TIE-LINE 637 WOOD-TO-STEEL PROJECT
MINOR PROJECT REFINEMENT
REQUEST FORM

Date Requested:	June 20, 2014	Report #:	011
Date Approved:	July 1, 2014	Approval Agency:	No other agency approval is required.
Property Owner(s):	Private and SDG&E Right-of-Way (ROW).	Location/Milepost:	Near Structure Location P72
Land Use/ Vegetative Cover:	The proposed impact area occurs primarily within disturbed habitat (agriculture/ orchard lands).	Sensitive Resources:	None
Refinement / Modification From (check all that apply):			
<input type="checkbox"/> Permit	<input type="checkbox"/> Plan/Procedure	<input type="checkbox"/> Specification	<input type="checkbox"/> Drawing
<input type="checkbox"/> Mitigation Measure (MM)			
<input checked="" type="checkbox"/> Other: Overland Travel Route to Distribution Pole and Overhead Work.			
<p>San Diego Gas & Electric Company (SDG&E) is proposing to perform overhead work at an existing distribution pole (herein designated as Structure No. D193) and utilize an overland travel route to the pole. The pole is located on the north side of the main existing access road (Oak Hollow Road) between Structure Nos. P71 and P72. The overhead work and overland travel access to St

Figure 1: MPR Overview Map showing the location of the proposed work at Structure No. D193 off of the main access road (dashed red line) between P71 and P72.

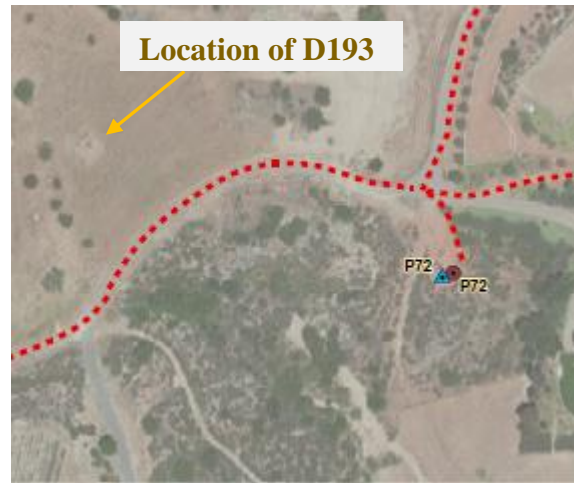
Description of Refinement			
<p>SDG&E proposes to perform overhead work at Structure No. D193 and utilize a new overland travel route to the pole from the main existing access road.</p> <p>The new proposed overland travel route to access Structure No. D193 is approximately 150 feet long by 14 feet wide, and will result in approximately 2,100 square feet of temporary impacts to non-native vegetation. Proposed overhead work at Structure No. D193 will require a temporary workspace within an approximately 10-foot radius around the pole location, resulting in 310 square feet of temporary impacts to bare ground. Figure 2 depicts the proposed new overland travel route and location of proposed overhead work at Structure No. D193. Photograph Nos. 1 and 2 depict the new proposed overland travel route and temporary workspace area.</p>			
Original Condition:			
<p>The new proposed overland travel route and temporary workspace area at Structure No. D193 occurs off of the existing project approved main access road (Oak Hollow Road) in a location that was not identified as a temporary workspace area within the PTC Application (PEA) or Final IS/MND for the TL 637 Project.</p>

Justification for Change:			
<p>Following in-field review, construction crews identified the need to conduct overhead work on an existing distribution pole (Structure No. D193) that occurs on private land and requires the utilization of an overland travel route to the location. Minor modifications are necessary at Structure No. D193 to complete stringing activities for the Project.</p>

Figure 2: Aerial image of the temporary workspace area at Structure No. D193 and proposed overland travel route (purple line) off of existing access road (dashed red line).

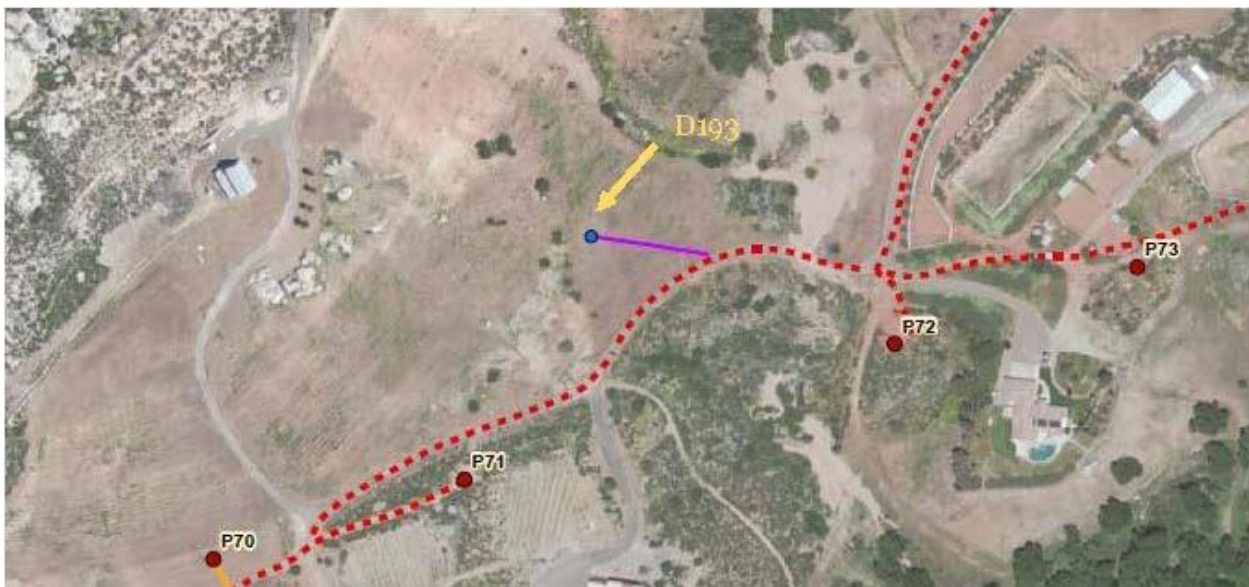
The new proposed overland travel route and Structure No. D193 modifications occur on private land (refer to Figure 2). The private landowners have approved the proposed construction modifications. No additional concurrence is required for the proposed MPR.
